Jason Creek (Reid Road) Assessment

Client: Squamish-Lillooet Regional District

Date: March 26, 2022

In January 2022, BGC was asked to provide third-party review of the Cordilleran report.

Cordilleran (December 13, 2021)

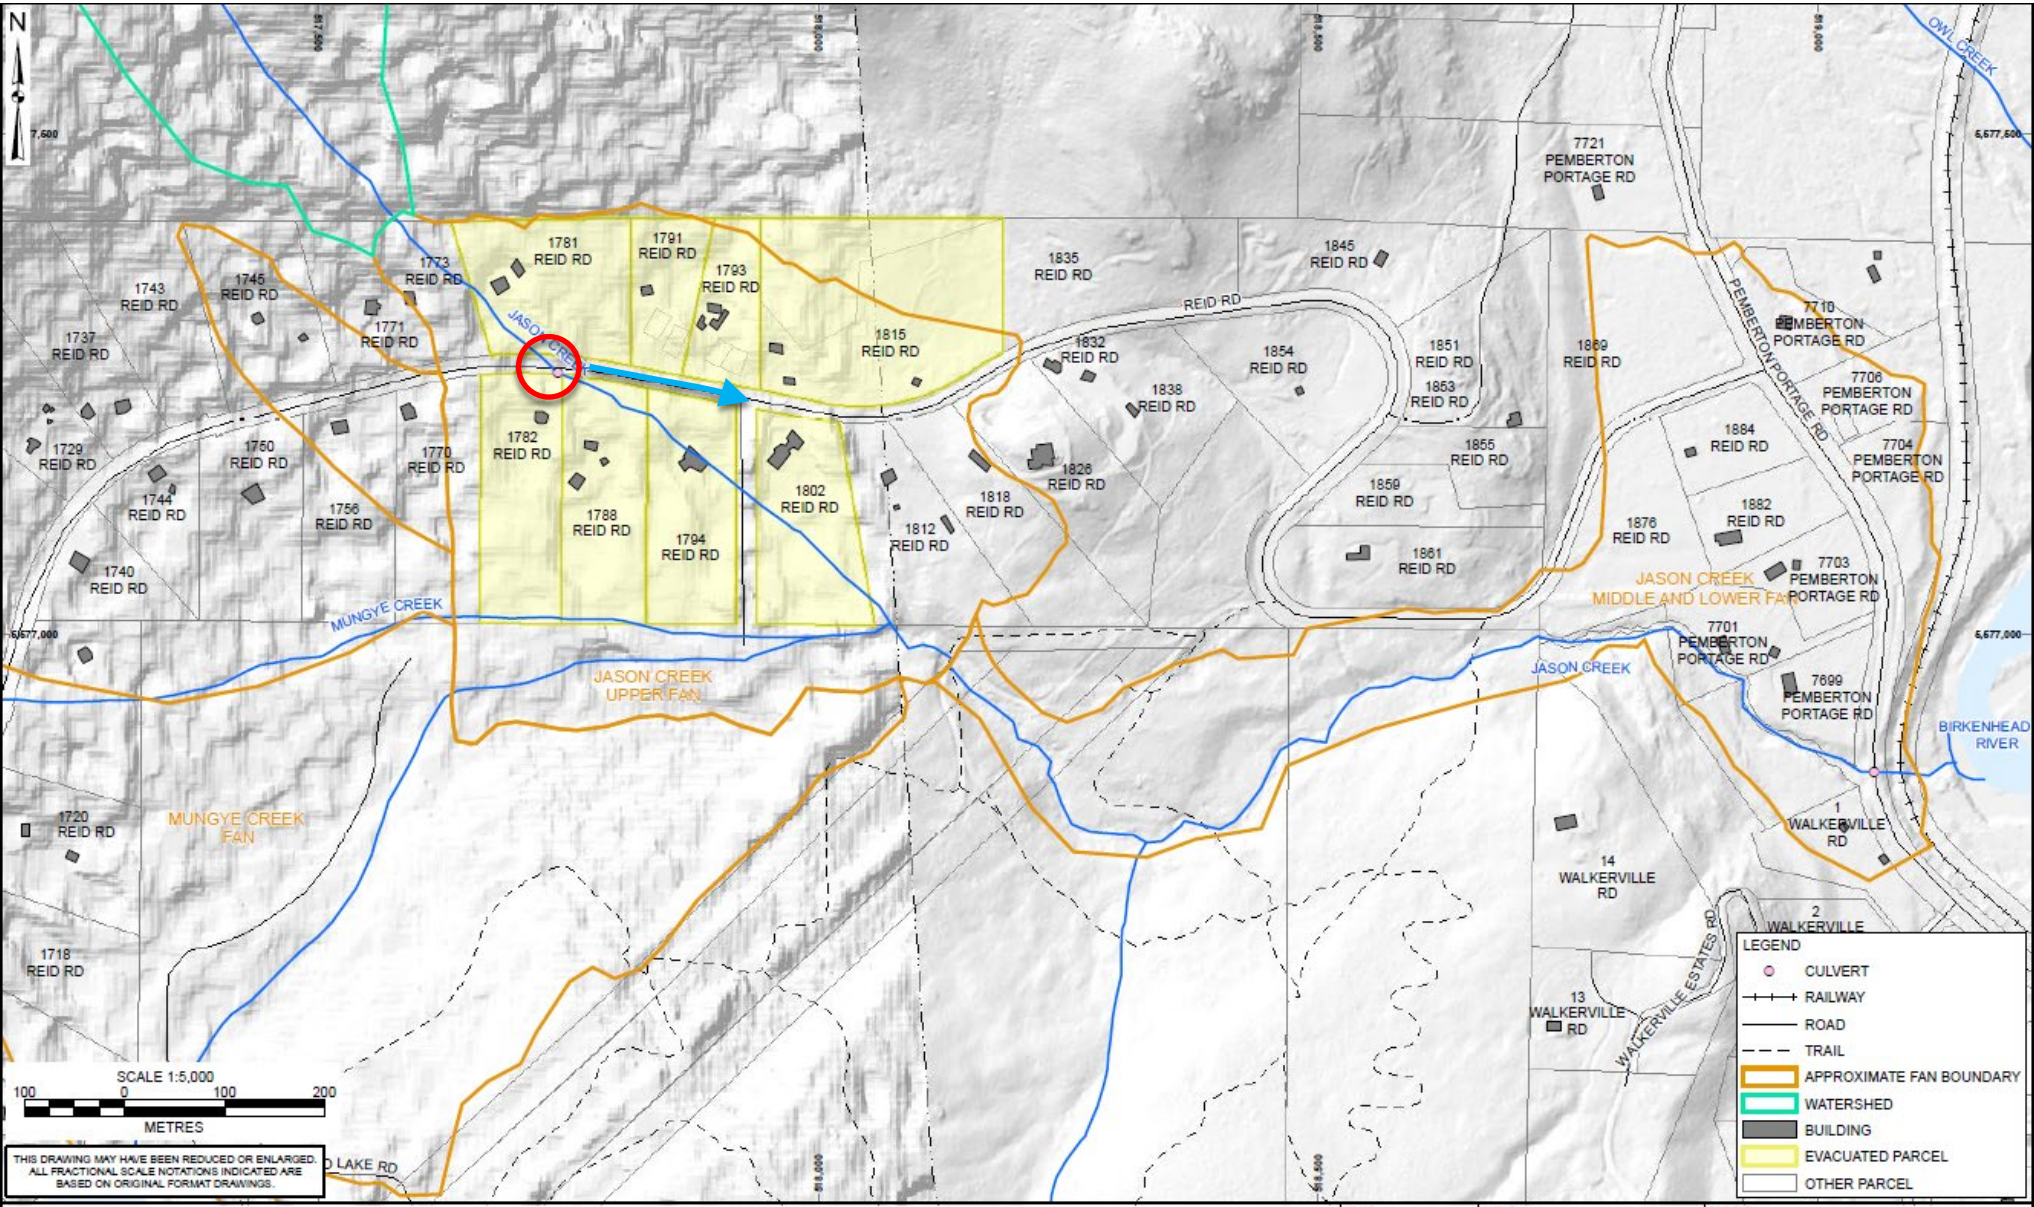
Jason Creek watershed is subject to a range of hazard types, including rock slope failures and debris flows.
 Additional work is required to assess potential failure volumes, probabilities, and magnitudes.

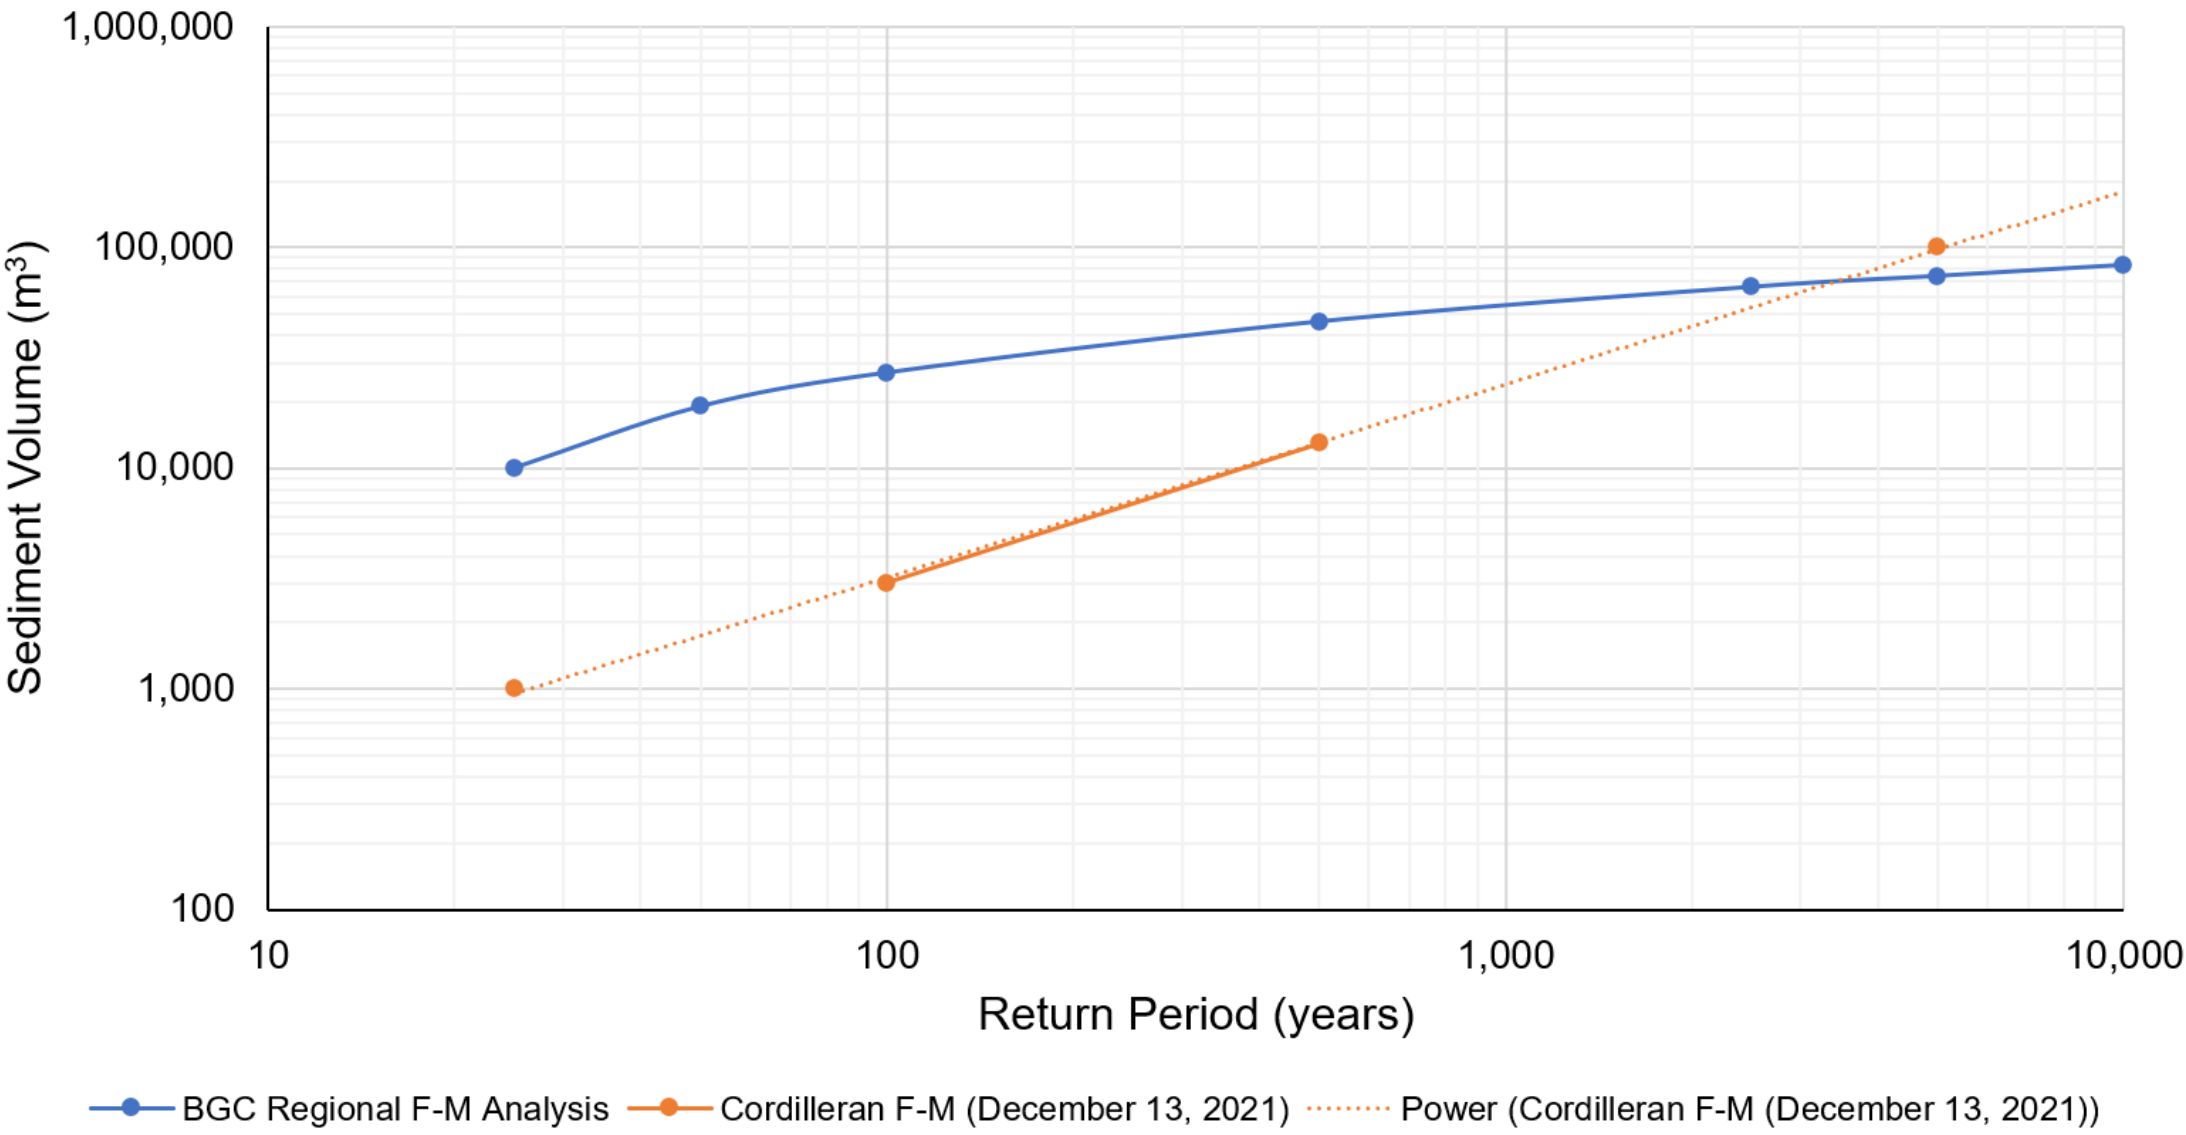
The F-M relationships developed for Jason Creek are preliminary.

Future work should consider:

- Different triggering events (rainfall vs. rockslide)
- Climate change
- Post-fire debris flows

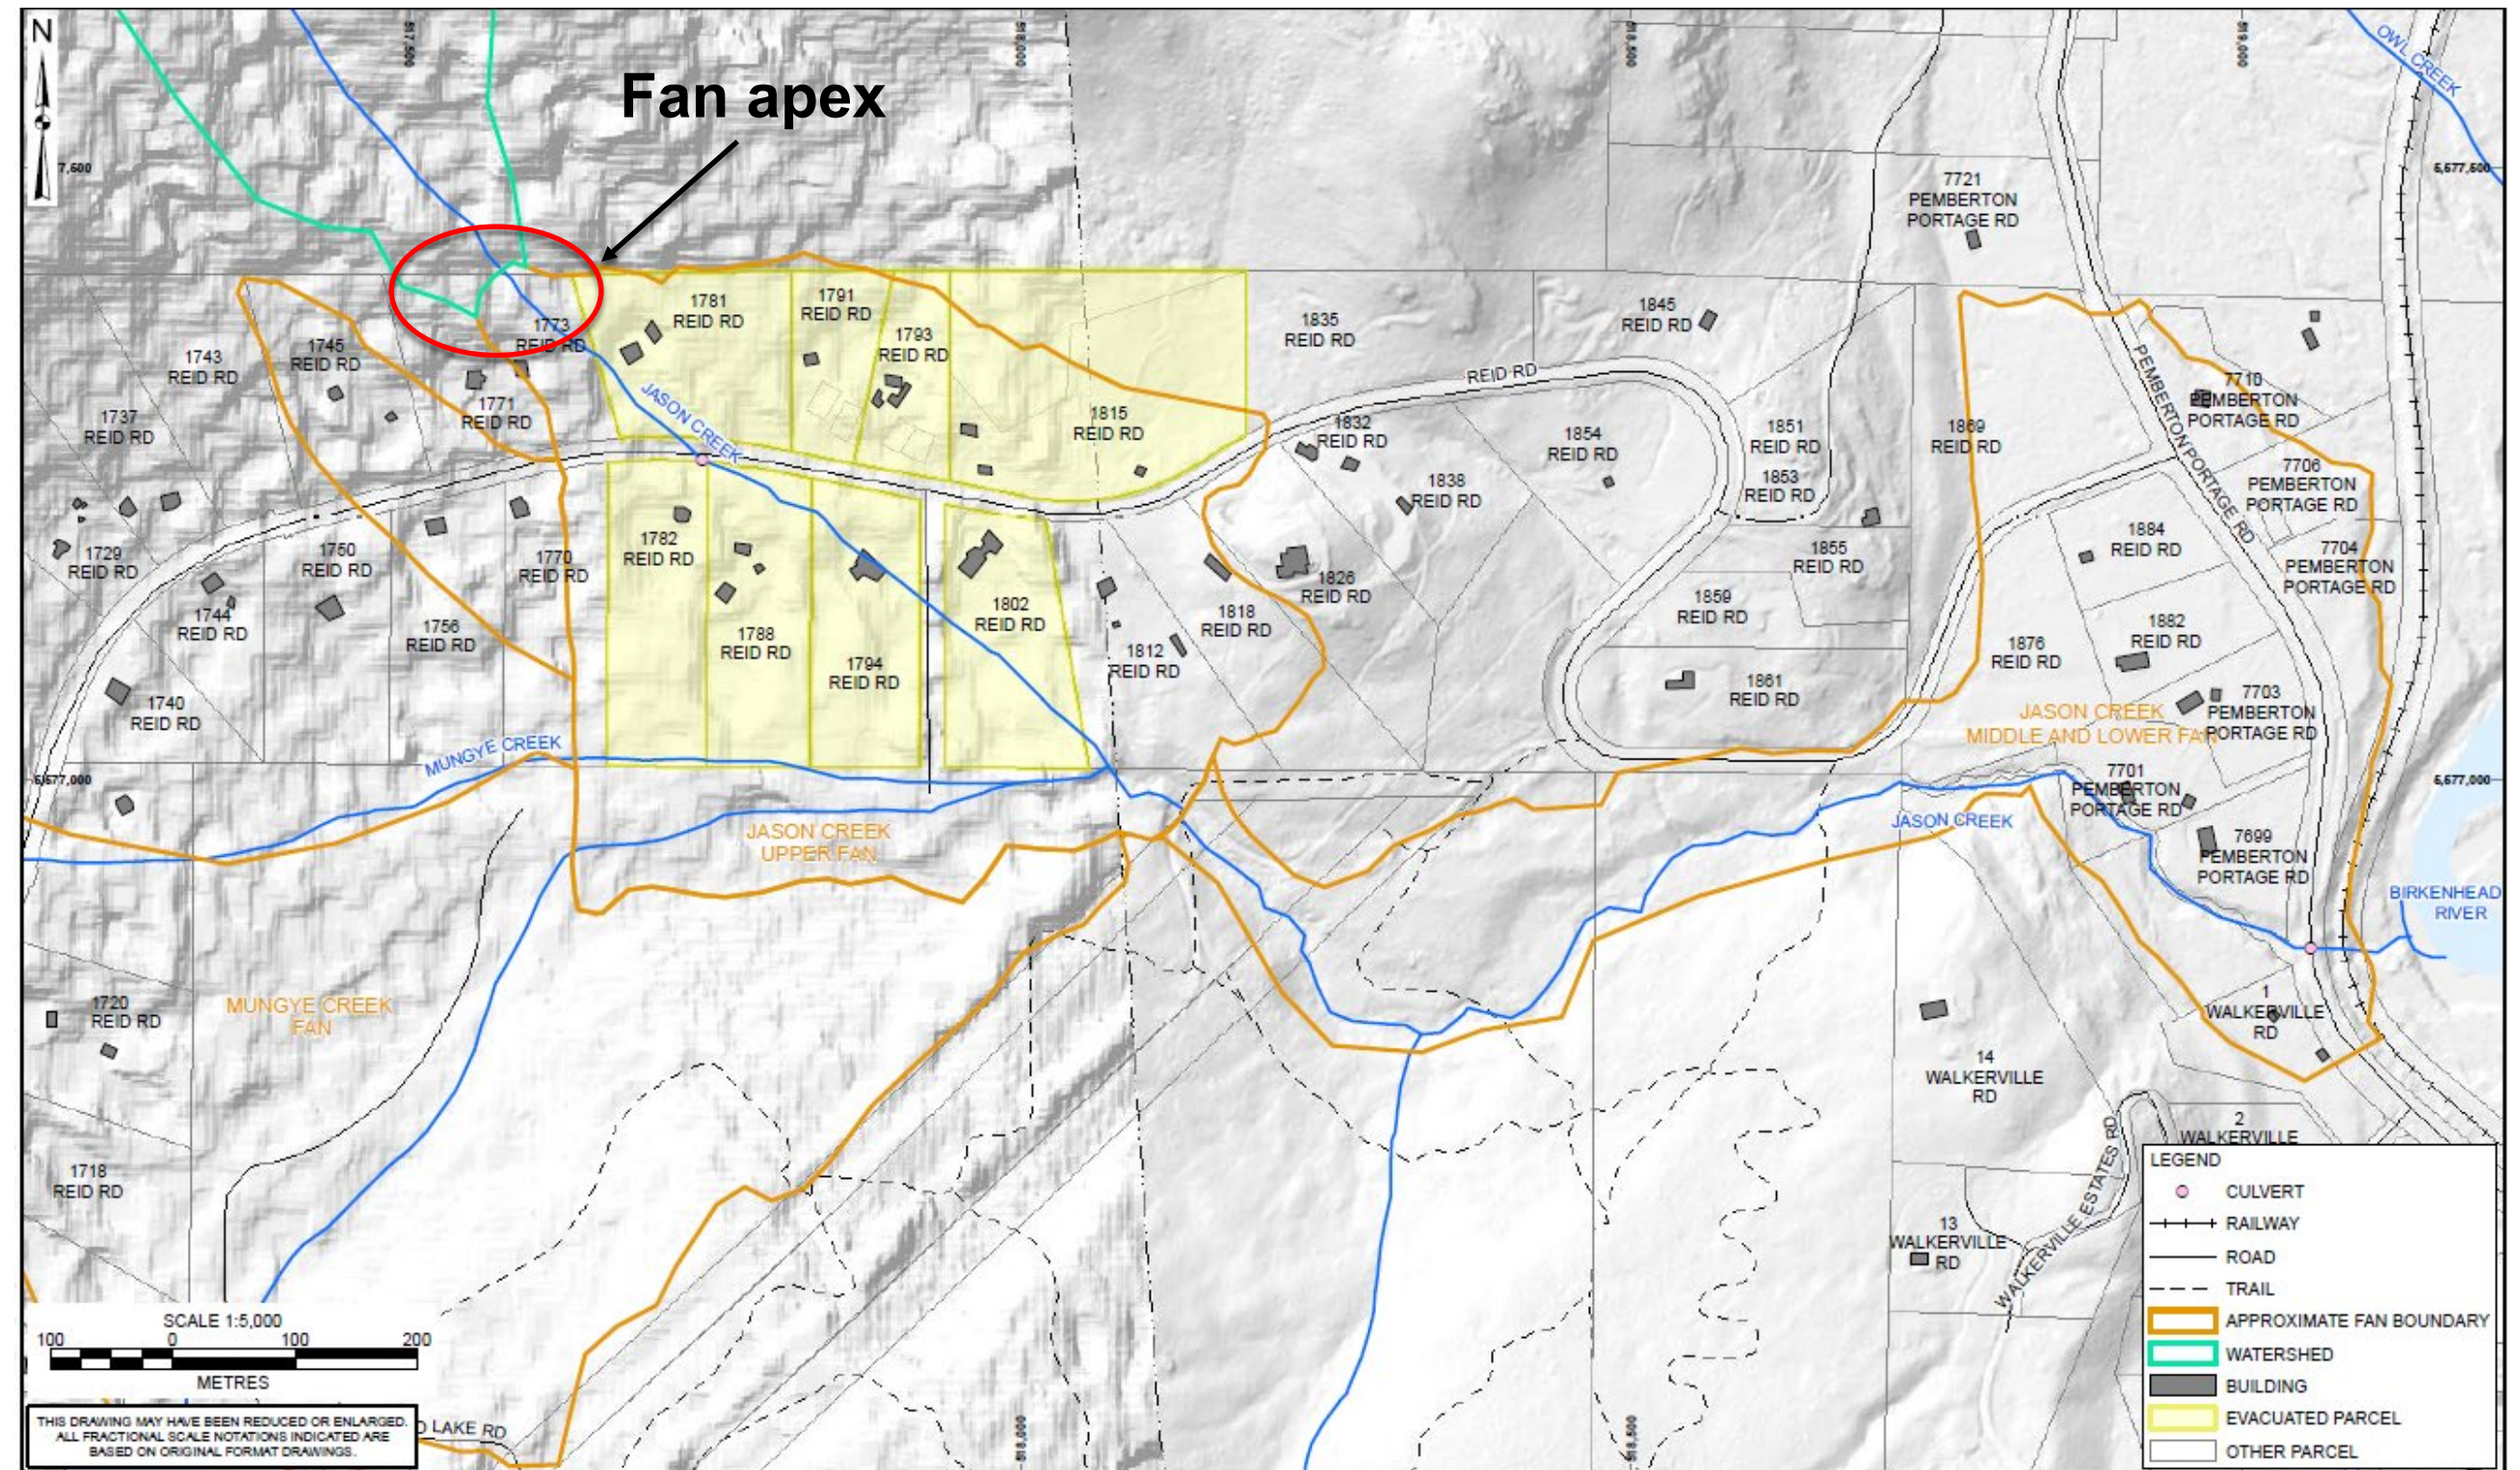
Debris-flow life-loss risk is highest near the fan apex and likely decreases with distance from the fan apex.

Extent of reduction in debris-flow risk with distance from the fan apex can only be hypothesized at this stage.
